## Certificate of Appropriateness

2757 N. LAKE DR. North Lake Drive HD

**Date issued** 2/10/2020 PTS ID 114909 COA: porch repairs

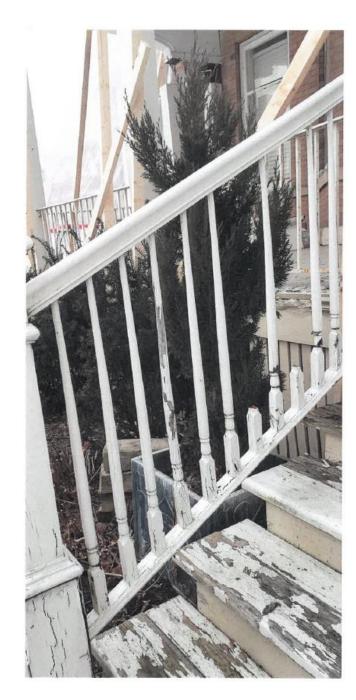
Stair railing to be replicated, but with new balusters as at right.
